MONTGOMERY COUNTY HISTORIC PRESERVATION COMMISSION
STAFF REPORT

Address:	8 E. Irving St., Chevy Chase	Meeting Date:	6/27/18
Resource:	Contributing Resource Chevy Chase Village Historic District	Report Date:	6/20/18
Applicant:	Dana Beyer	Public Notice:	6/13/18
Review:	HAWP	Tax Credit:	N/A
Case Number:	35/13-18O RETROACTIVE	Staff:	Dan Bruechert
Proposal:	Replace Driveway

LOCATION SURVEY OF 8 EAST IRVING STREET MONTGOMERY COUNTY, MARYLAND	LOT: 5, PART OF 4	BLOCK: 26
	LIBER 1023	FOLIO 350
SECTION No 2	PLAT BOOK:	PLAT NO:
CHEVY CHASE	DATE: 1-14-88	SCALE: 1" = 20'
	CASE NO: 14811	FILE NO: RC-

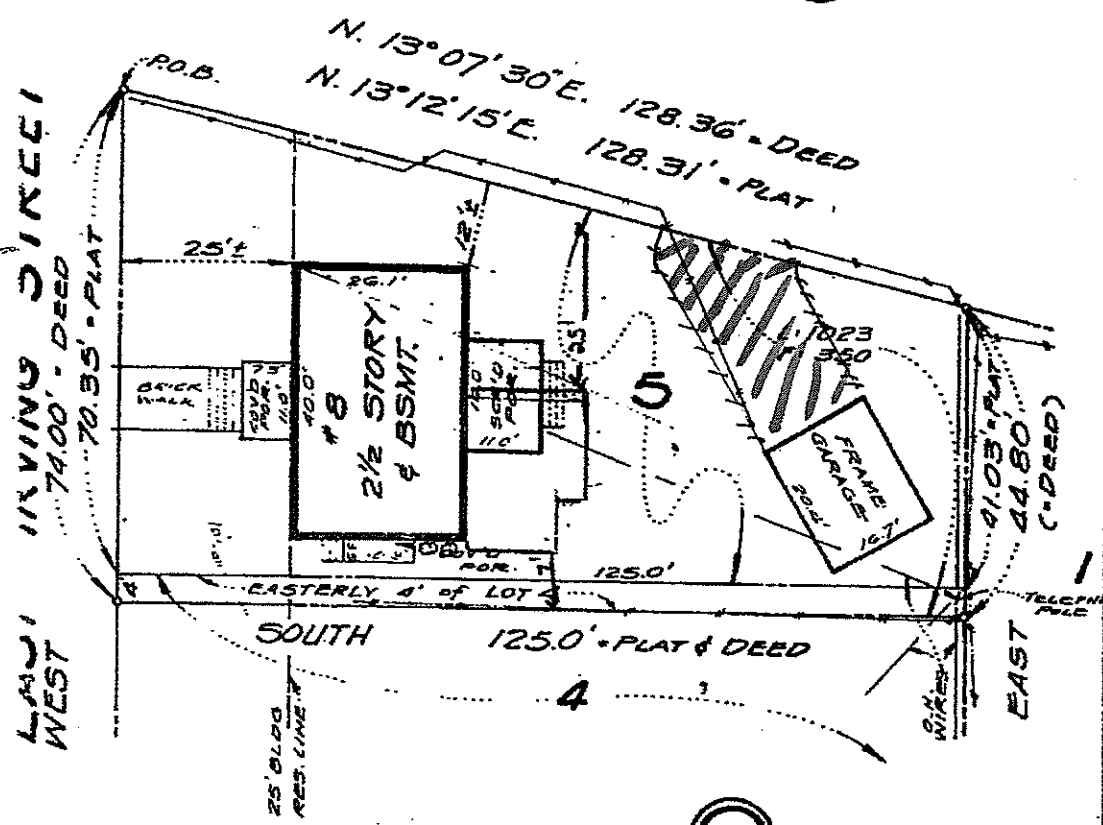
The driveway for the subject property is access from the rear of the lot off of Brookville Rd. Staff has confirmed through Google Street View that prior to 2018, the driveway was constructed out of asphalt. Asphalt is generally a disfavored material in the Chevy Chase Village Historic District, because the material is so dark and has a uniform texture. Lighter colored material – though not bright white concrete – with some textural variation is preferred.

The applicant proposes installing Eco Dublin concrete block set on a sand base. Per the *Design Guidelines*, evaluation of this proposal is subject to strict scrutiny in consideration of its impact on mature trees. In this instance, the proposed work will not impact any mature trees. All other consideration of this driveway replacement is subject to lenient scrutiny. Staff finds that the material is consistent with the house and surrounding district. Staff additionally finds that the overwhelming majority of the work is occurring behind a privacy fence and will not be visible from the public right-of-way. Staff supports approval of this HAWP.

Staff recommends the HPC **approve** the HAWP application; and with the general condition applicable to all Historic Area Work Permits that **the applicant will present 3 permit sets of drawings to HPC staff for review and stamping prior to submission for permits (if applicable)**. After issuance of the Montgomery County Department of Permitting Services (DPS) permit, the applicant will arrange for a field inspection by calling the DPS Field Services Office at 240-777-6370 prior to commencement of work and not more than two weeks following completion of work.
